UNITED STATES PATENT AND TRADEMARK OFFICE

Office Action Summary

09/954,806

DETAILED ACTION

Figure 4 shows the thickness of a positive electrode active material layer wherein P represents the electrode layer (section 0119).

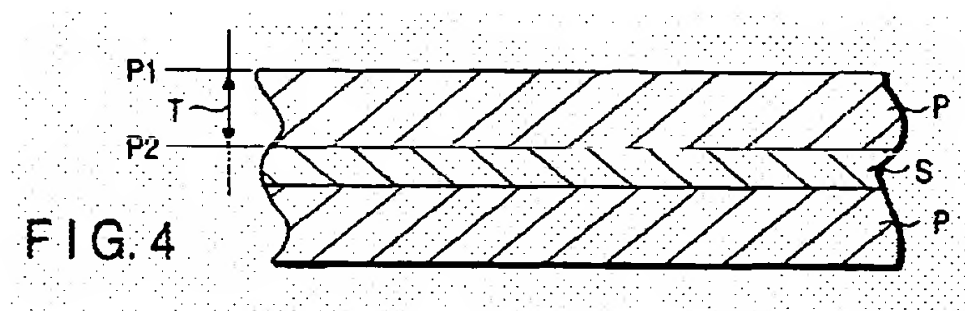
The EP'960 reference teaches that the thickness of the positive electrode layer should be 10-100 Tm; it follows that where positive electrode layers are formed on both surfaces of the collector, one positive electrode layer has a thickness of 10-100 Tm, naturally, the total thickness of the two positive electrode layers formed on both surfaces of the collector is 20-200 Tm. It is also disclosed that **the upper limit in the thickness is preferably 85 μm** (section 0119/ 0158) (*←emphasis added*). Hence, the EP'960 reference envisions the claimed thickness, at least, from 80 to 100 Tm when one layer is formed, and at least, from 80 to 200 μm when two layers are formed thereon.

The EP'960 reference teaches that the thickness of the negative electrode layer should be 10-100 Tm; it follows that where negative electrode layers are formed on both surfaces of the collector, one negative electrode layer has a thickness of 10-100 μm , naturally, the total thickness of the two negative electrode layers formed on both surfaces of the collector is 20-200 Tm. It is also disclosed that **the upper limit in the thickness is preferably 85 μm** (section 0125/ 0161) (*←emphasis added*). Hence, the EP'960 reference envisions the claimed thickness, at least, from 80 to 100 Tm when one layer is formed, and at least, from 80 to 200 μm when two layers are formed thereon.

Thus, given that the EP'960 reference has clearly disclosed that the upper limit in the thickness for both the positive electrode and the negative electrode is preferably 85 μm , as well, in general, electrode layers having a thickness of 10-100 μm , it is fairly reasonable to contend that the EP'960 reference envisions at first the claimed thickness, and consequently, the claimed ratio A/B. For instance, if the upper limit in the thickness for the positive electrode is chosen to be 85 μm , then the thickness of the negative electrode can be thus chosen to be 81 μm which still satisfies a preferred electrode thickness; or in the other hand, if the positive electrode thickness is chosen to be 100 μm , then the thickness of the negative electrode can be thus chosen to be 96 which is still within the generally disclosed range. In this regard, it is noted that this examiner's position is taken in light of the specific electrode thickness exemplified in TABLE 6 (See portions of TABLE 6 below) which shows positive electrodes and negative electrodes having different thickness dimension. Therefore, the EP'960 reference does not strictly require that the thickness dimension of both electrodes (i.e. the positive electrode and the negative electrode) be identical or the same. In other others, the EP'960 reference at once envisages different thickness for both

electrodes. Thus, the battery of the EP'960 still meets the claimed ratio (A/B) requirement of being equal to or greater than 1.038.
